Project	IEEE 802.16 Broadband Wireless Access Working Group < http://ieee802.org/16 >	
Title	STC mode of operation in an OFDMA SFN environment	
Date Submitted	2003-07-16	
Source(s)	<p>Yossi Segal Itzik Kitroser Yigal Leiba Zion Hadad Runcom Technologies Ltd. 2 Hachoma St. 75655 Rishon Lezion, Israel</p> <p>Avi Freedman Hexagon System Engineering 21c Yegi'a Kapa'im st. P.O. Box 10149 Petach Tikva, 49001 Israel</p>	<p>Voice: +972-3-9528440 Fax: +972-3-9528805 mailto:itzikk@runcom.co.il mailto:yossis@runcom.co.il mailto:yigall@runcom.co.il mailto:zionh@runcom.co.il</p> <p>Voice: +972-3-9224420 Fax: +972-3-9224396 mailto:avif@hexagonltd.com</p>
Re:	Contribution elaborating on comments for letter ballot #11a	
Abstract	This document presents the STC mode of operation in OFDMA.	
Purpose	To be integrated into P802.16d/D3-2003 draft document	
Notice	This document has been prepared to assist IEEE 802.16. It is offered as a basis for discussion and is not binding on the contributing individual(s) or organization(s). The material in this document is subject to change in form and content after further study. The contributor(s) reserve(s) the right to add, amend or withdraw material contained he

Figure 128bo12—Illustration of STC

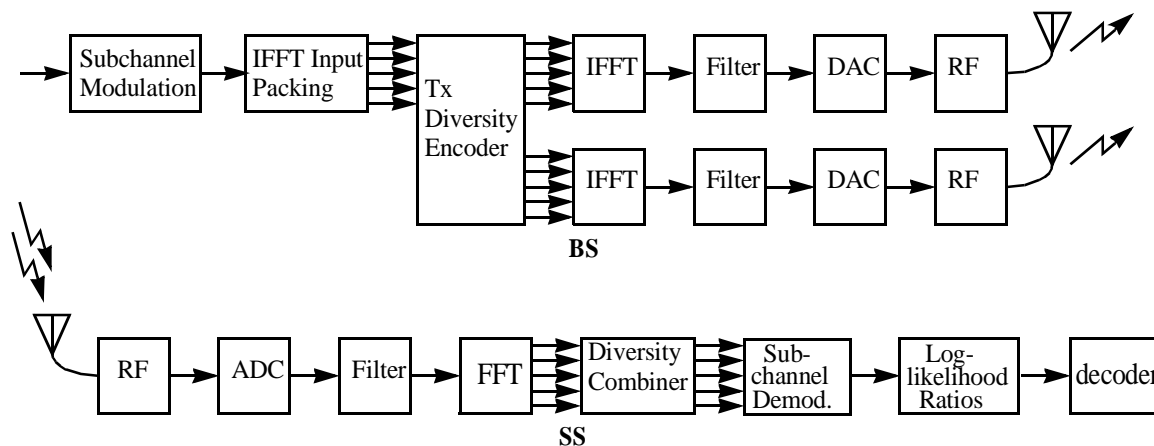
Figure 128bo12 shows STC insertion into the OFDM chain. Each Tx antenna has its own OFDM chain, but they have the same Local Oscillator for synchronization purposes.

Figure 128bo13— STC usage with OFDMA

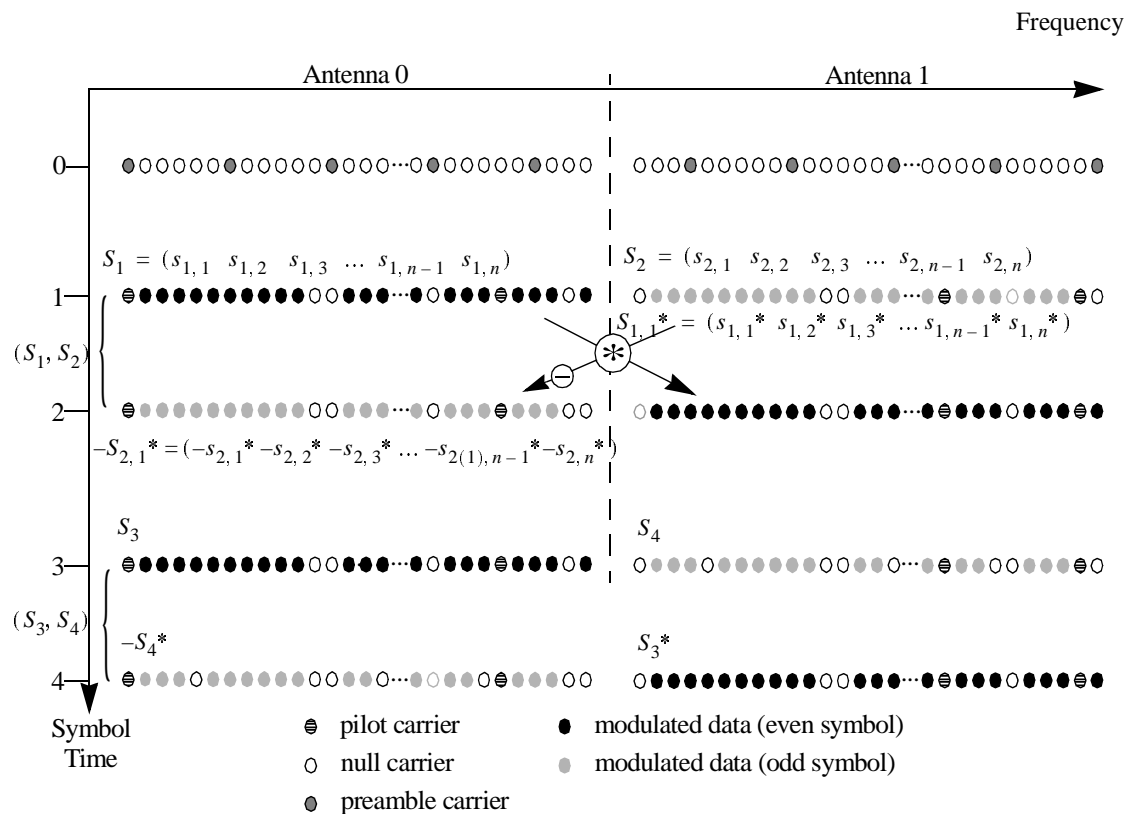
Figure 128bo13 shows STC for OFDMA. Note that since pilot positions do not change from even to odd symbols, and pilot modulation is real, conjugation (and inversion) can be applied to a whole symbol (possibly in the time domain).

Figure 128bo14—DL Frame Prefix sub-channel allocation for the combined operation of STC and non-STC transmission

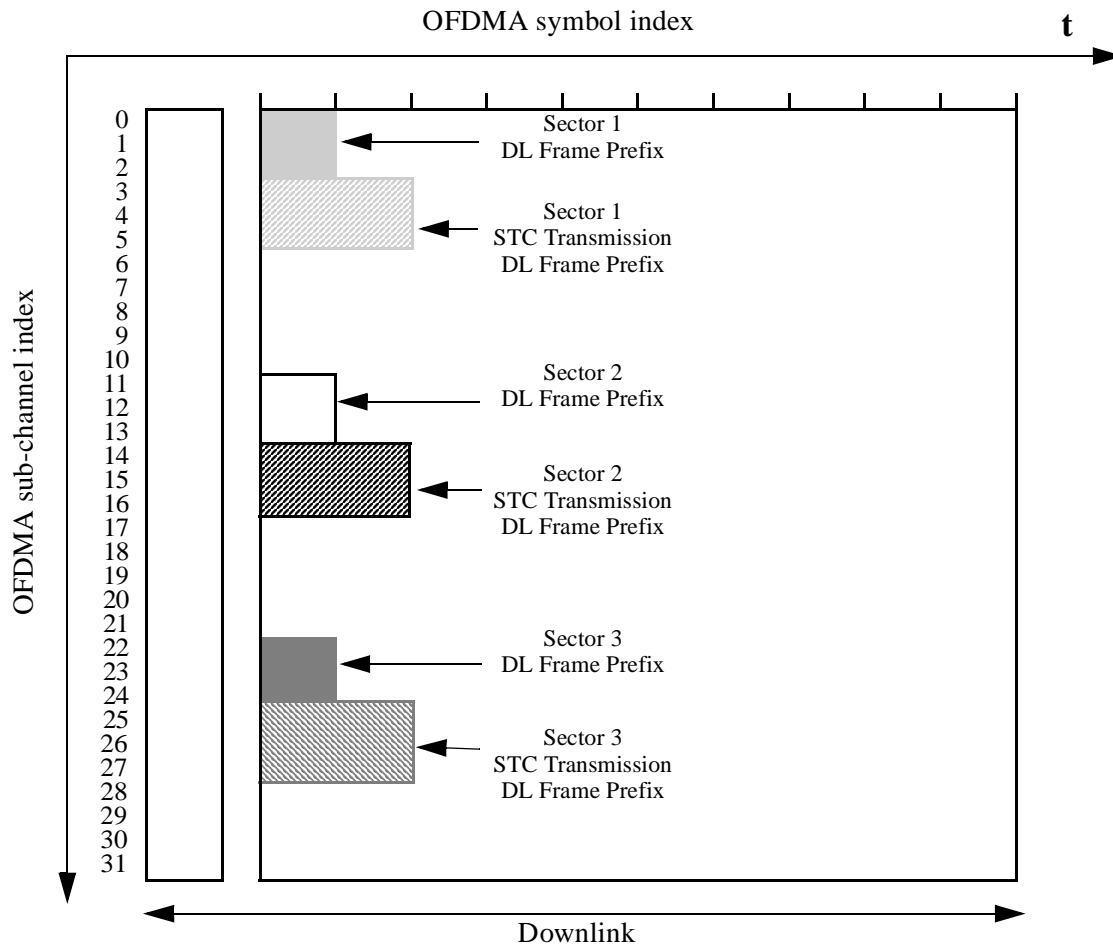
nels. The first three transmitted sub-channels in the first data symbol of the DL contains the FCH as defined in 8.5.4.2. For sector 1 Sub-channels 3-4 are used as the basic allocated Sub-Channels, for Sector 2 Sub-channels 14-16, for sector 3 Sub-channels 25-27.

In the following figure the structure of the DL Frame-Prefix Sub-Channel allocation (for the combined operation of STC and regular transmission) is shown:
